PLANNING, ZONING, & BUILDING DEPARTMENT
PZ&B Staff Memorandum: Town Council Development Review

SUBJECT: ZON-23-019 (COA-23-002) 363 COCOANUT ROW THE VINETA HOTEL (COMBO)

MEETING: FEBRUARY 15, 2023

PROPOSED COURTYARD ELEVATION

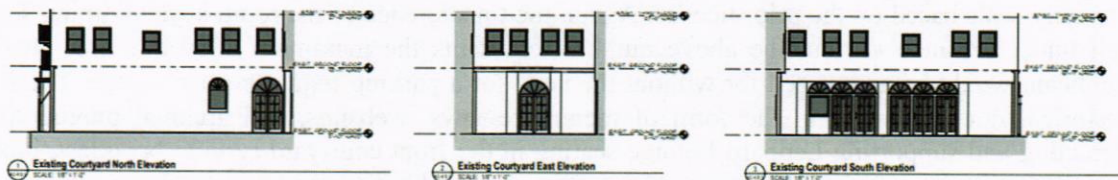
The Landmarks Preservation Commission has reviewed and approved the architectural changes as related to the proposed outdoor seating locations, vis a vis the front courtyard and the pool deck area. In both instances, additional openings are proposed. Within the front courtyard, the applicant is proposing new French door openings along the north and south interior elevations. This new fenestration alteration will unify the interior spaces of the main dining room and lounge both proposed to the north and south of the courtyard and likely allow both spaces to capitalize on the open-air nature of the courtyard for al fresco dining or cocktails. A total of 35 seats are proposed within a lounge located north

PROPOSED POOL LOUNGE ROOM ELEVATION

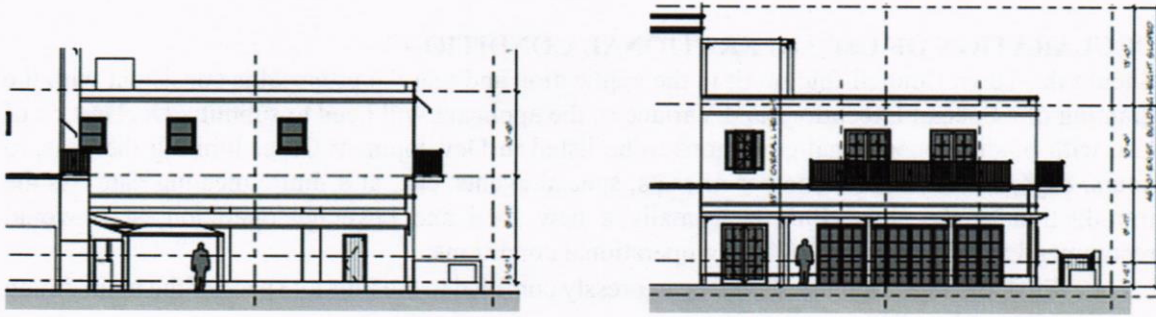
Within the rear pool deck area, the applicant is proposing a new operable NANA wall storefront system. This new fenestration alteration will allow the interior pool lounge to 'open up' onto the open-air pool deck area and provide for access to outdoor dining and drinking. A total of 52 seats are proposed in and around the pool bar towards the eastern portion of the site and 16 of which are

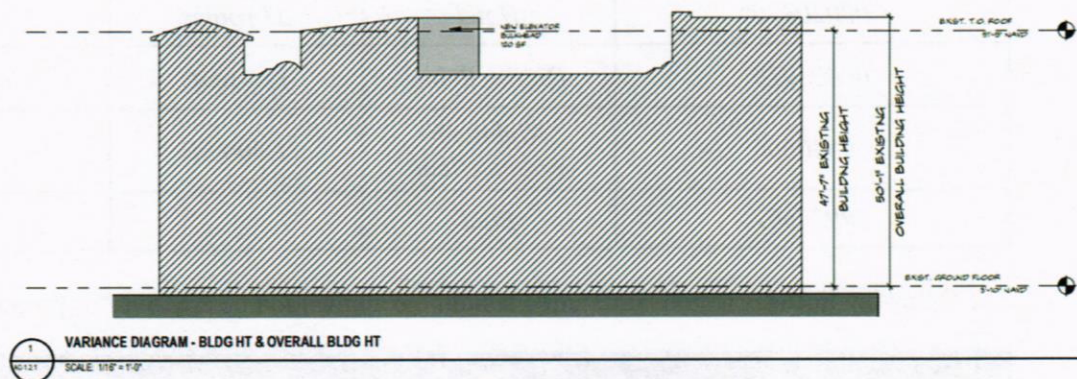
VARIANCE 2: Sec. 134-948(8)d: A variance to exceed the maximum allowable height for new rooftop construction specifically to replace an elevator and stair bulkhead on the rooftop of a nonconforming four-story building with a height of 47.6 ft in lieu of the 23.5 ft maximum building height allowed.

VARIANCE 3: Sec. 134-948(8)d: A variance to exceed the maximum allowable height for new rooftop construction specifically a rooftop trellis on a nonconforming third floor and of a nonconforming four-story building with a height of 33'0" in lieu of 23'6" maximum height and 26'6" maximum building height permitted.

As it pertains to Variance #2 and #3 to exceed maximum height of rooftop trellis on a nonconforming third floor and to replace an elevator and stair bulkhead on the nonconforming building, staff has no objections to the request as it technical in nature as the Code does not contemplate nonconforming buildings in zoning districts as it pertains to rooftop improvements when the zoning limits the number of stories below that existing edifice.

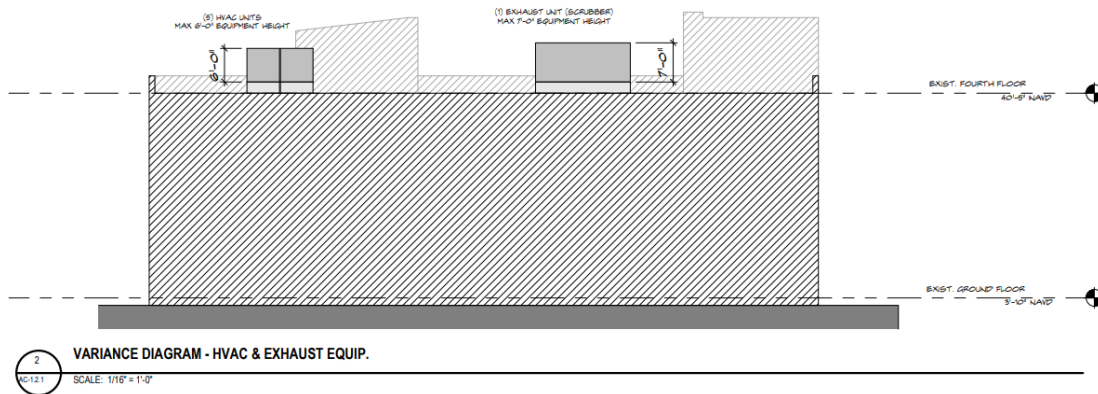
VARIANCE 4: Sec. 134-1607(1): A variance to exceed the maximum allowable height for the installation of rooftop air conditioning units (five) at a height of 108" (9') above the maximum height permitted in lieu of the 48" (4') maximum height allowed.

VARIANCE 5: Sec. 134-1607(1): A variance to exceed the maximum allowable height for a roof top commercial kitchen exhaust scrubber at a height of 84" (7') above the maximum height permitted in lieu of the 36" (3') maximum height allowed.

As it pertains to Variance #4 and #5 to exceed maximum height of mechanical equipment (AC and Scrubber) on the existing roof. Staff has no objections to the request as it is the logical placement of such equipment, provided that the existing parapet wall or other screening methods adequately mitigate any negative visual impact when viewing the building from within the r-o-w or across the street. The placement of the equipment is setback from the immediate edges of the building and should be visually obscured. Staff would recommend that the applicant install sound attenuating material to ensure that the mechanical noise level does not become disruptive to the residential neighbors abutting the subject property to the south and to the east in the form of a noise barrier that offers soundproofing.
